**Meghan Pump Station (RFCSP)
Solicitation Number: CO-00645
Job No.: 19-1006**

**ADDENDUM 7
November 2, 2023**

MEGHAN PUMP STATION
CONTROL BUILDING & ACCESSORIES DETAILS

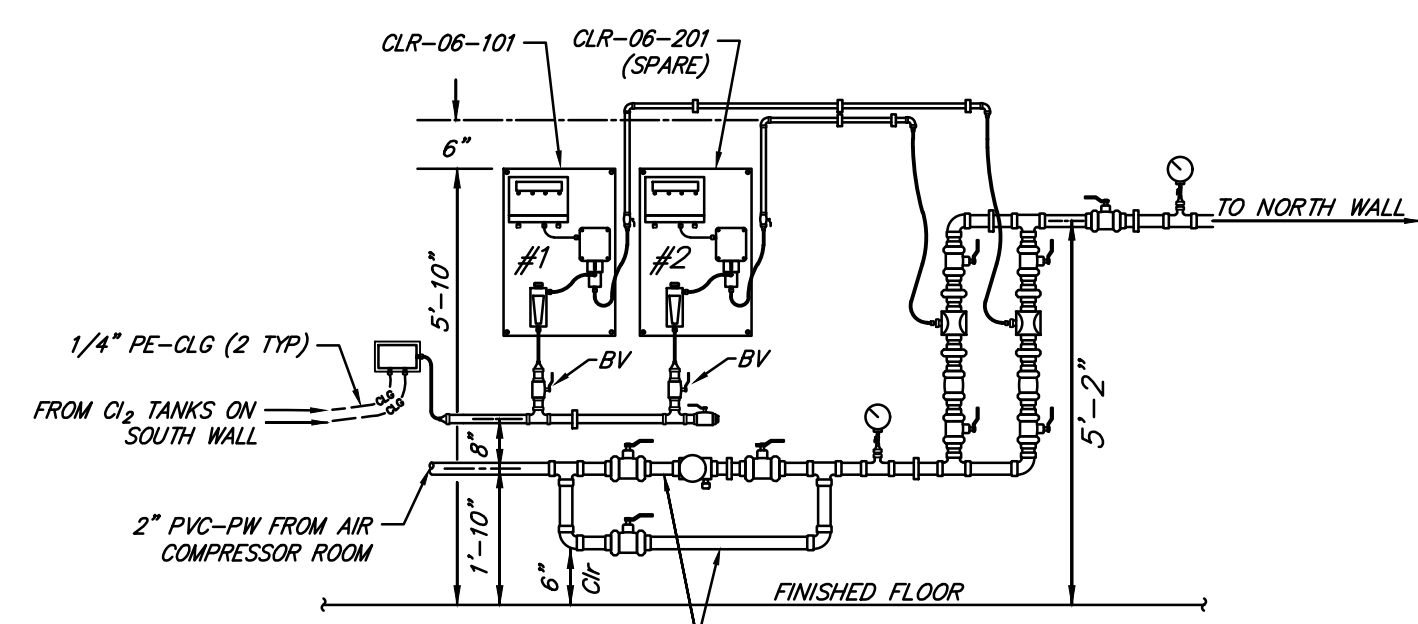
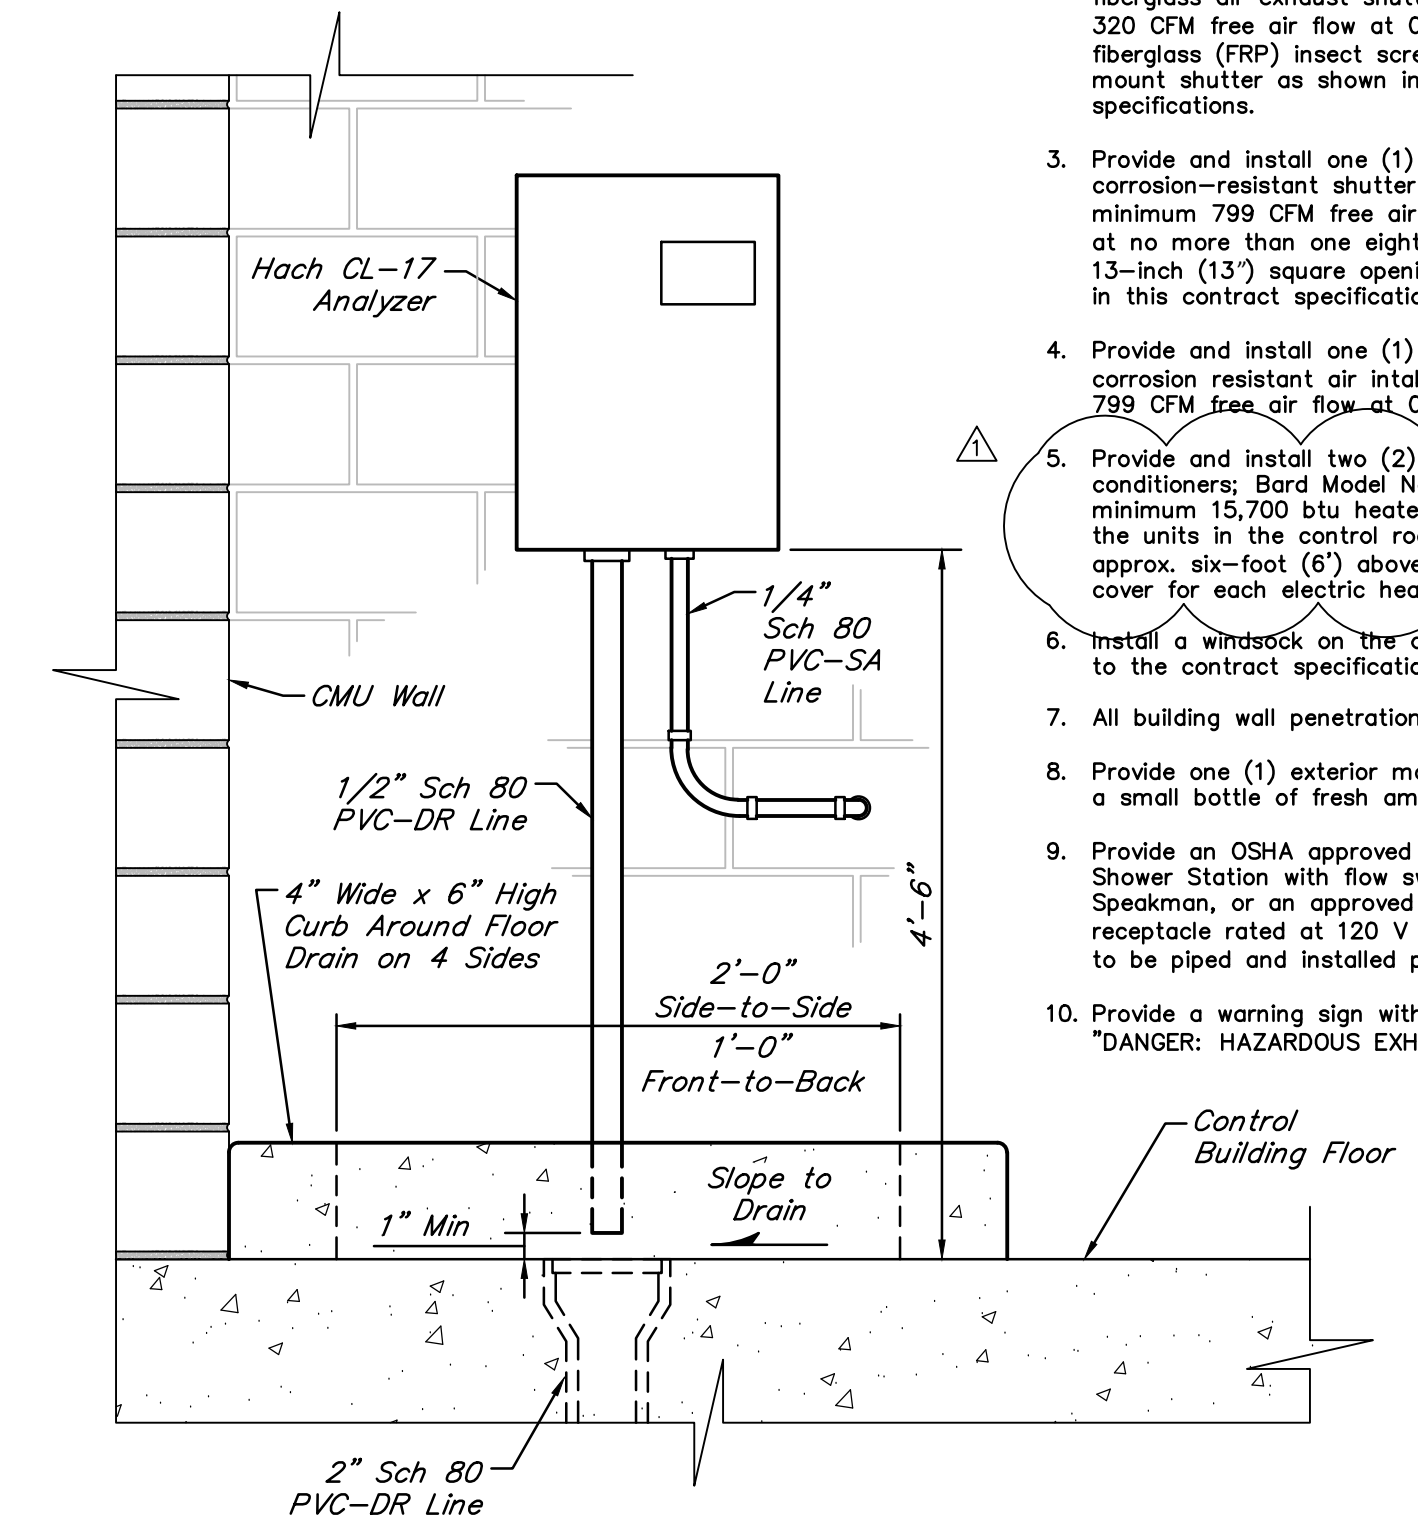
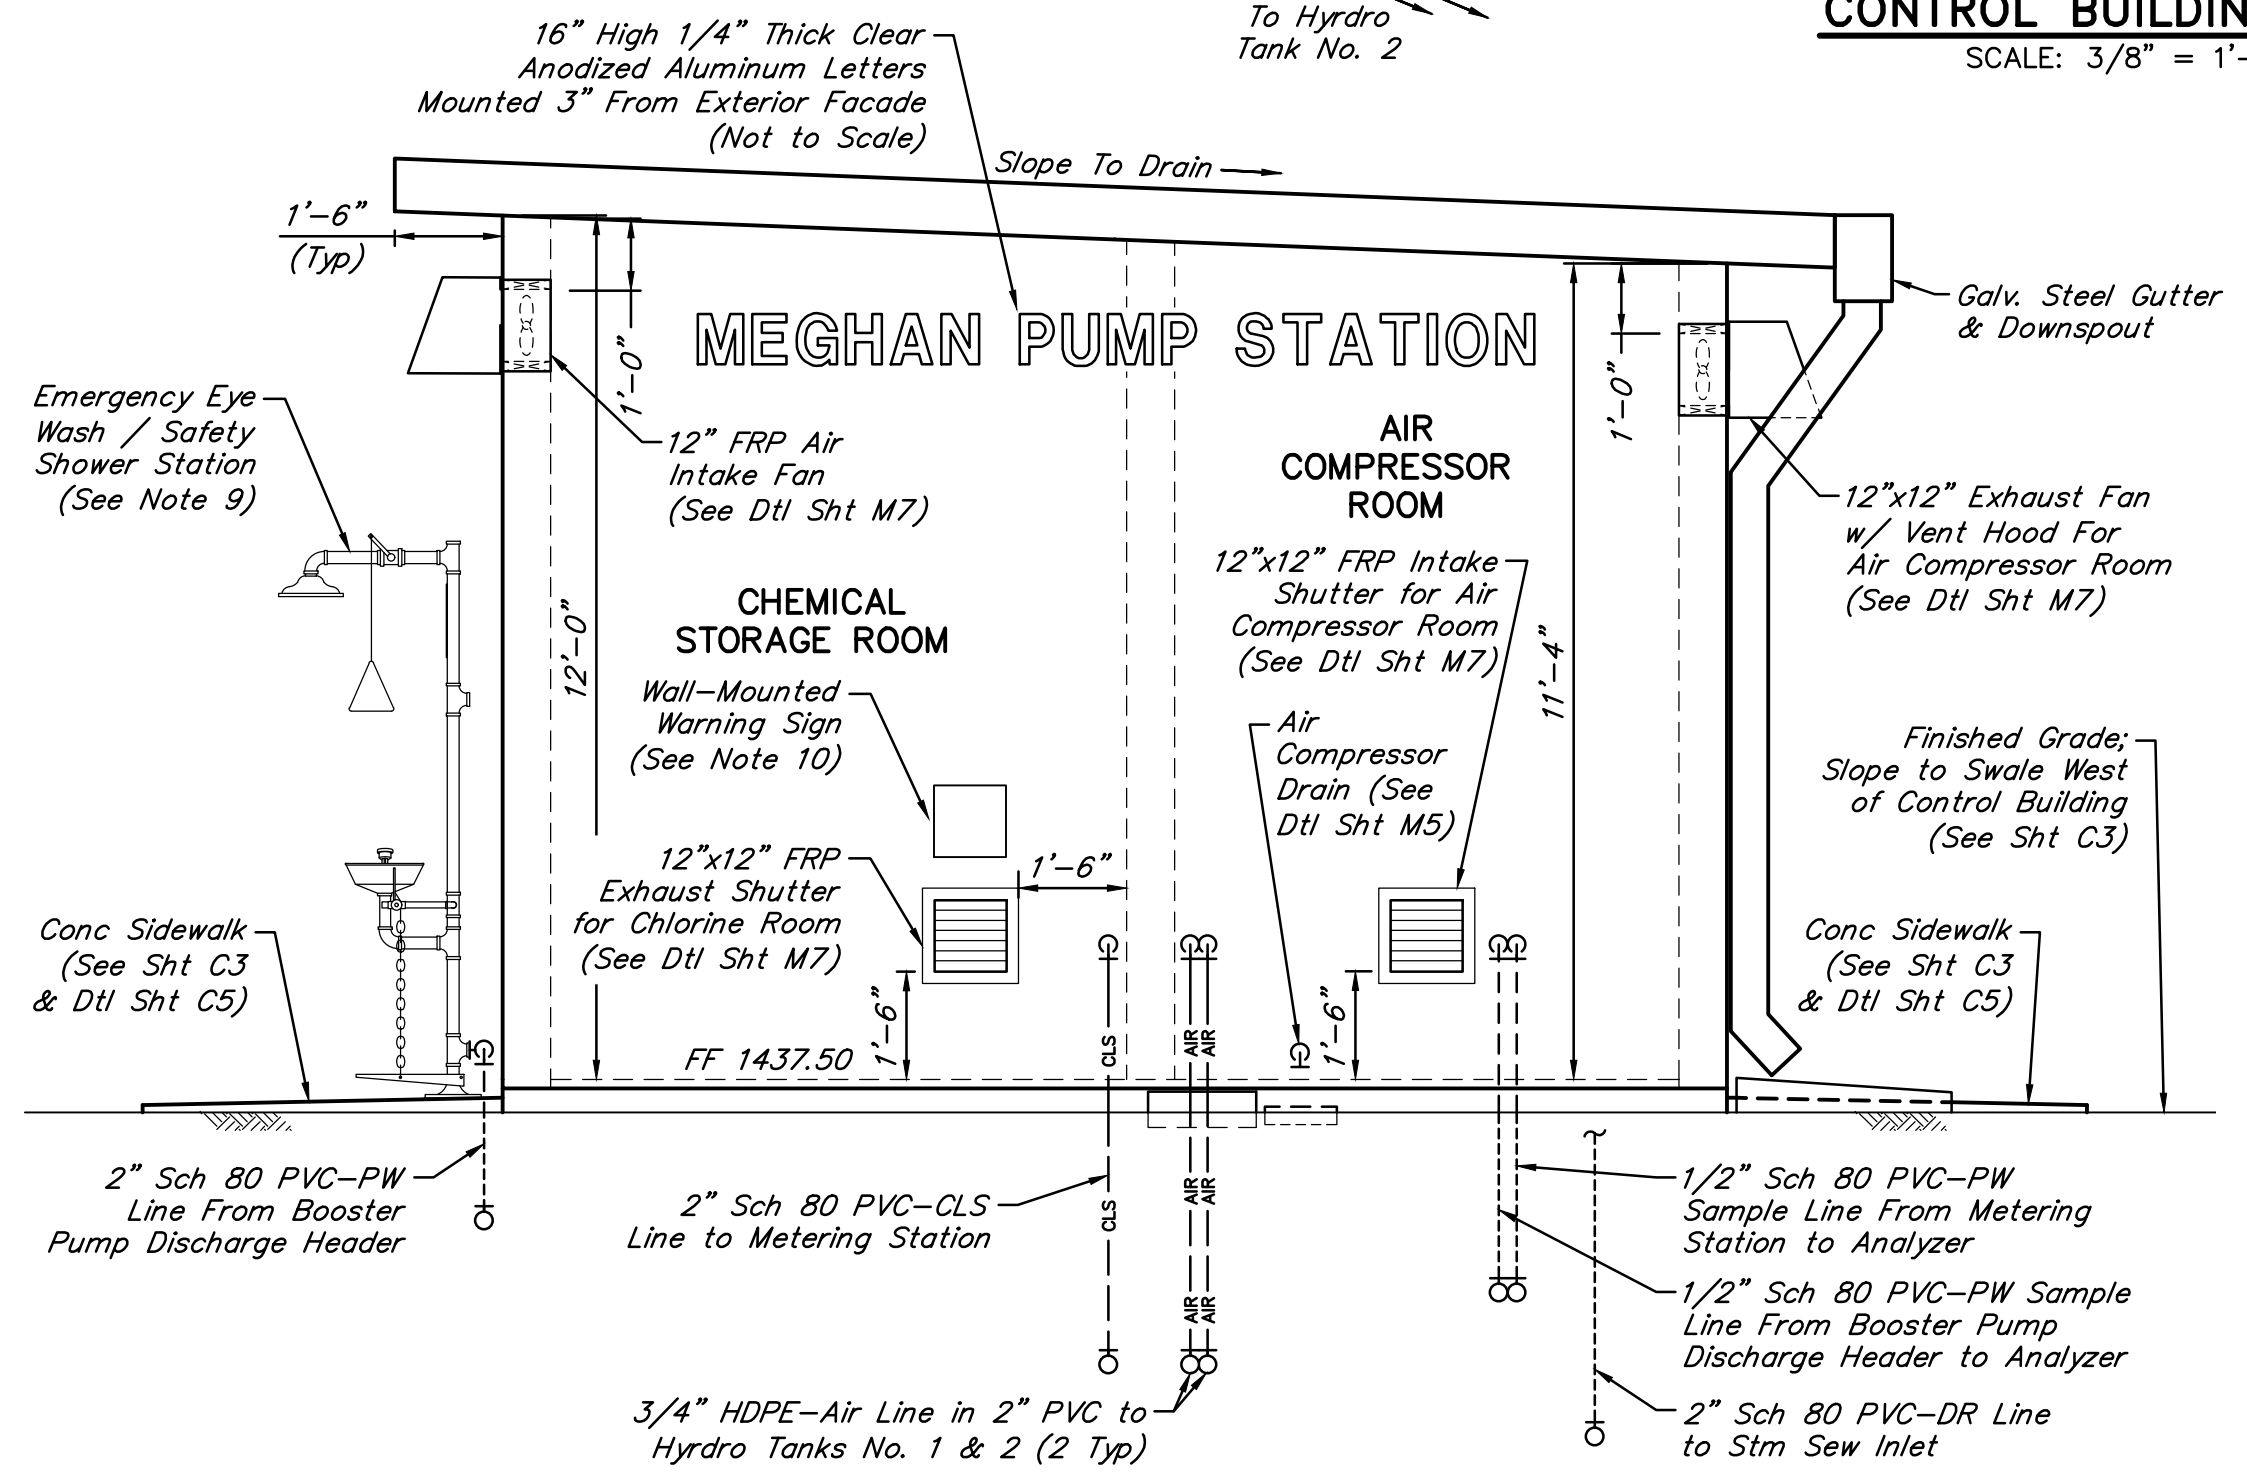
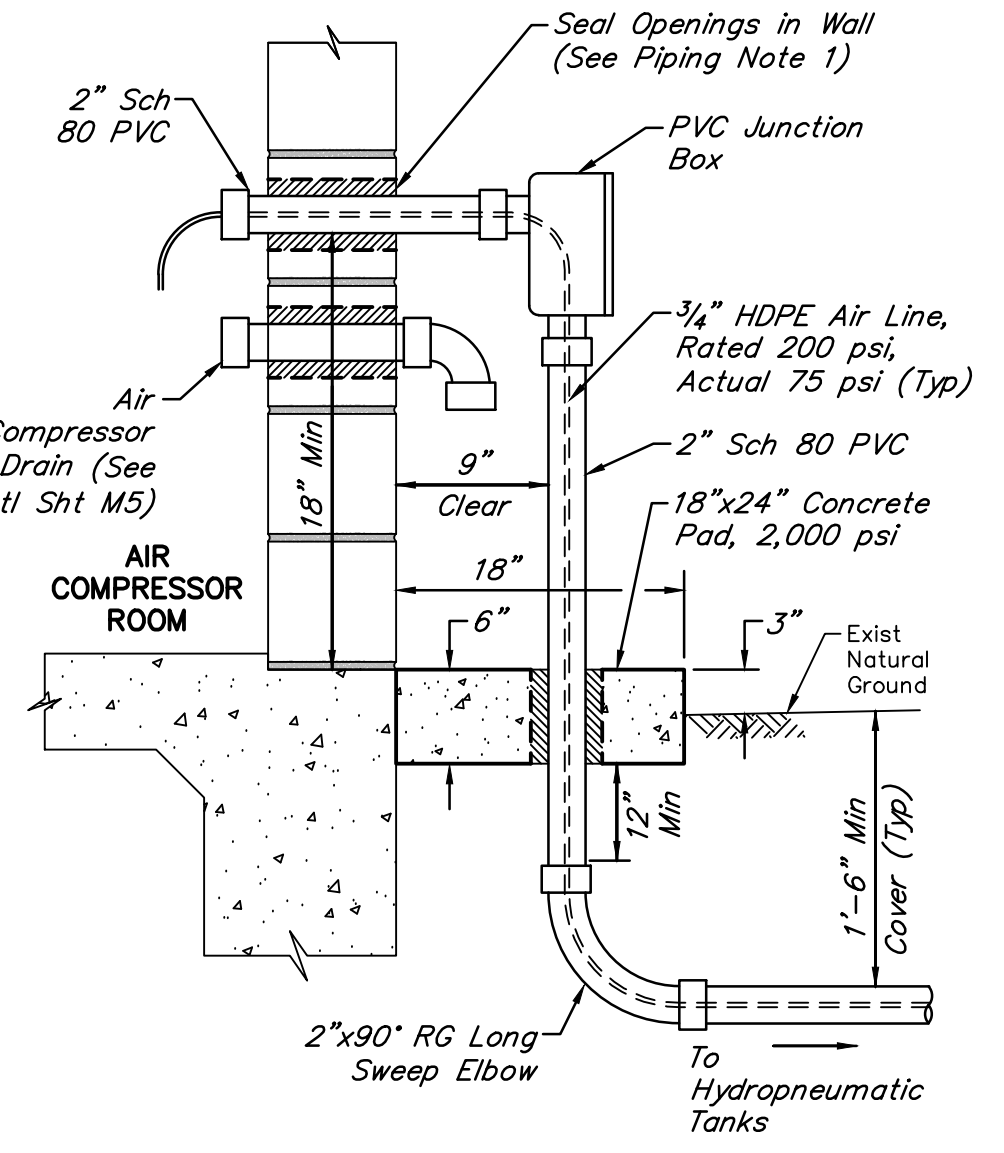
- 2. Question:** Spec Sec 15201 Item 2.2 Air Conditioner calls to provide and install two (2) Bard Model No. W24BB-XC05X5X electrical heat air conditioners. However, the specified model is not valid. I have attached the current Bard nomenclature sheet that will hopefully help confirm the model number. Please advise if the model number should be W24AY-C05XXXX5J.

Response: See changes to plans and specifications, this addendum. Confirmed. The correct model number is W24AY-C05XXXX5J. The indicated revisions to the plans and spec have been made.

- Provide and install two (2) through the wall exterior mounted electric heat air conditioners: Bard Model No. W24A7-C05XXXS1 or approved equal, capable of a minimum 15,700 btu heater output and 24,400 btu air conditioner output. Mount the units in the control room using a through wall sleeve, with top of units approx. six-foot (6') above the finished floor. Provide a thermostat with locking cover for each electric heat air conditioner.
